HISTORIC AND DESIGN REVIEW COMMISSION

HDRC CASE NO: 2017-274

ADDRESS: 526 E COURTLAND PLACE

TYPE OF WORK: Construction of rear accessory structure

WALL HEIGHT: 8'-1"	WIDTH	24-0"
	DEPTH	30'-0"
	AIDGE HE	IGHT: 13-2*
	FLOOR A	REA: 720 SF

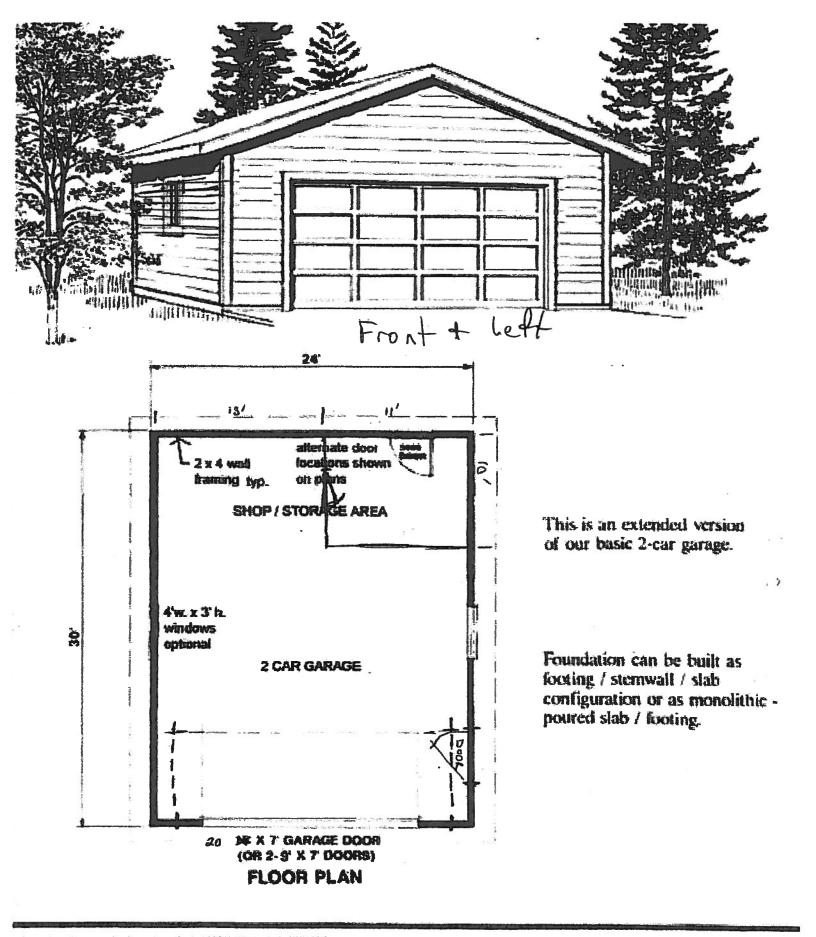
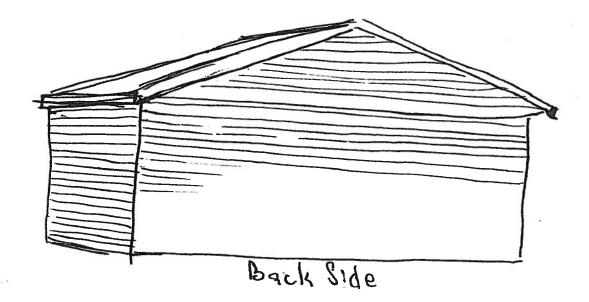
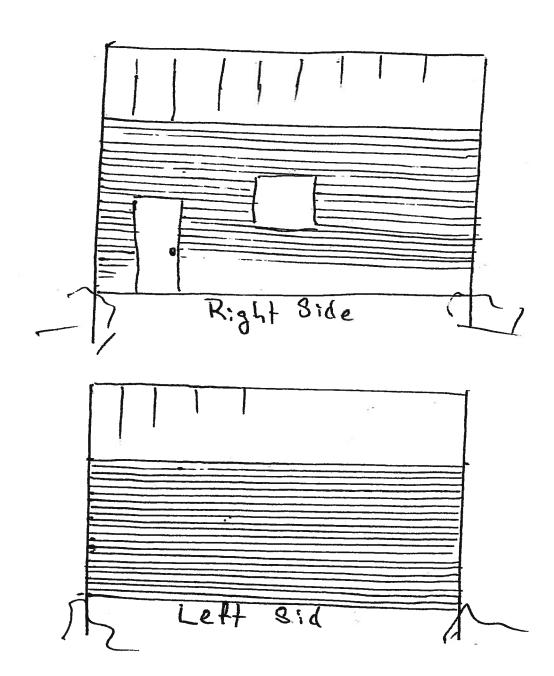
- b. FOOTPRINT The applicant as proposed to construct a new 1-story accessory structure in the rear of the lot. The proposed first floor footprint is approximately 720 square feet. The Historic Design Guidelines for Additions stipulate that new garages and outbuildings should be less than 40% the size of the primary structure in plan. Staff finds the footprint to exceed this percentage. However, the primary structure is 2 stories tall, and historic accessory structures that exceed the 40% stipulation are common in the Tobin Hill Historic District. Staff finds the proposal consistent with the Guidelines based on these site and district specific considerations.

- d. SCALE & MASS The applicant has proposed a 1-story accessory structure with a gable roof. The Historic Design Guidelines state that new construction should be consistent with the height and overall scale of nearby historic buildings. The scale of the proposed structure does not impact or visually compete with the 2-story primary structure. Staff finds the proposal consistent with the Guidelines.

- e. ROOF—The applicant has proposed a single gable roof. The roof will be constructed of standing seam metal to closely match the materiality of the primary structure. Staff finds the proposal consistent with the Guidelines.

- f. GARAGE DOOR The applicant has proposed to install two single overhead metal garage doors. The doors will measure nine by seven feet and will feature paneling with historic design influences. According to Guideline 5.A.v for New Construction, garage doors with similar proportions and materials as those traditionally found in the district should be used on new structures. Staff finds the configuration and proportions consistent with the Guidelines. Additionally, the doors will not be visible from the public right-of-way. Guideline 4.A.iii states that contemporary materials should not distract from the historic structure. Staff finds the use of the submitted metal doors appropriate for this proposal based on their style, proportions, and detailing, as well as the location of the proposed structure on this particular lot.

- g. WINDOW & DOOR OPENINGS The applicant has proposed to install one fixed four panel window and one solid core door. According to the OHP Window Policy Document, windows used in new construction should maintain traditional dimensions and profiles found on the primary structure or within the historic district. Staff finds the window and door sizes and placement consistent with the Guidelines, but has yet to receive information on the material.

- h. MATERAILS: FAÇADE The applicant has proposed to use woodlap siding on the façade that matches the siding of the primary structure as closely as possible. Guideline 3.A.i for New Construction states that materials should complement the type, color, and texture of those found in the historic district. Staff finds the proposal consistent with the Guidelines.

- i. That the applicant submits final window, door, and roof specifications to staff for approval.
- ii. That the applicant complies with the OHP Checklist for Metal Roofs.
- iii. That the applicant submits final measured drawings to staff for approval that reflect the use of two garage doors and contain all necessary dimensions prior to receiving a Certificate of Appropriateness.
- iv. That the applicant meets all setback standards as required by city zoning requirements, and obtains a variance from the Board of Adjustment if applicable.
